North Central Texas
Council of Governments

**Recommended Regional Amendments to the
2018 International Swimming Pool and Spa Code**
North Central Texas Council of Governments Region

ADD: Figure: 25 TAC §265.186 (e) (6)

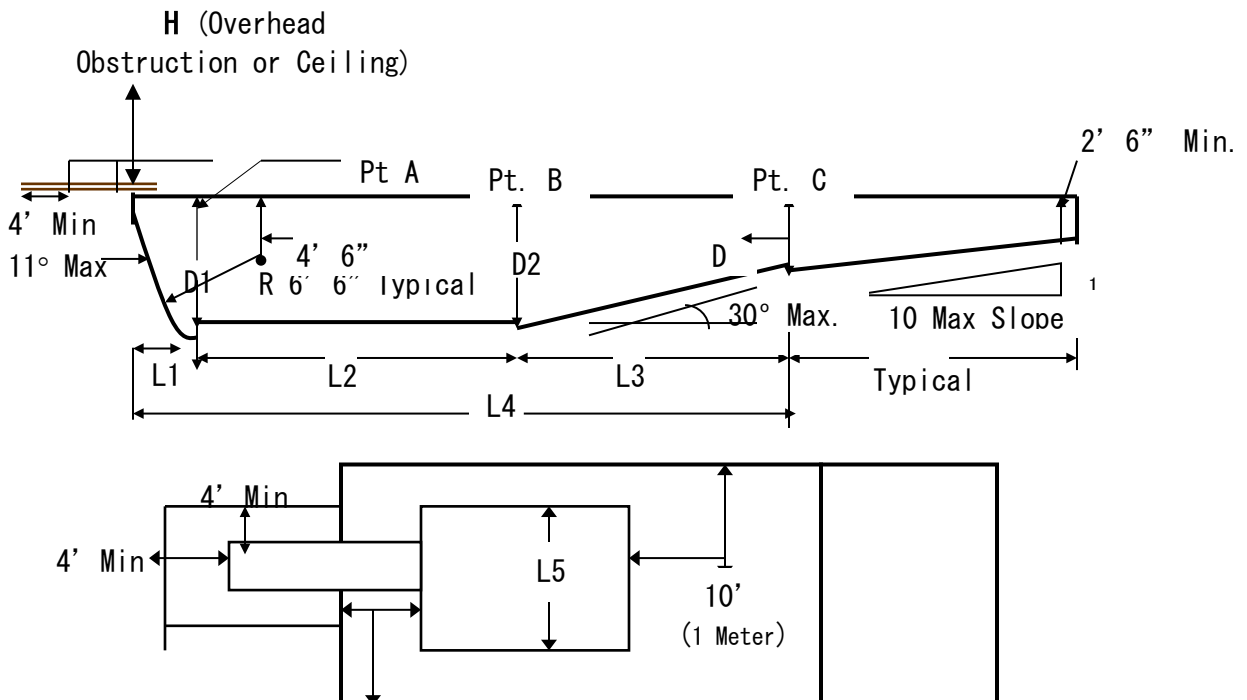
402.12 Water envelopes. The minimum diving water envelopes shall be in accordance with Table 402.12—Texas department of State Health services, Administrative Code Title 25, Chapter 265, Section 186 (e) and Figure: 25 TAC 256.186 (e) (6). (Delete Table 402.12 and Figure 402.12)

Maximum Diving Board Height Over Water	¾ Meter	1 Meter	3 Meters
Max. Diving Board Length	12 ft.	16 ft.	16 ft.
Minimum Diving Board Overhang	2 ft. 6 in.	5 ft.	5 ft.
D1 Minimum	8 ft. 6 in.	11 ft. 2 in.	12 ft. 2 in.
D2 Minimum	9 ft.	10 ft. 10 in.	11 ft. 10 in.
D3 Minimum	4 ft.	6 ft.	6 ft.
L1 Minimum	4 ft.	5 ft.	5 ft.
L2 Minimum	12 ft.	16 ft. 5 in.	19 ft. 9 in.
L3 Minimum	14 ft. 10 in.	13 ft. 2 in.	13 ft. 11 in.
L4 Minimum	30 ft. 10 in.	34 ft. 7 in.	38 ft. 8 in.
L5 Minimum	8 ft.	10 ft.	13 ft.
H Minimum	16 ft.	16 ft.	16 ft.
From Plummet to Pool Wall at Side	9 ft.	10 ft.	11 ft. 6 in.
From Plummet to Adjacent Plummet	10 ft.	10 ft.	10 ft.

(Reason: To avoid conflict with 25 TAC Chapter 265.)
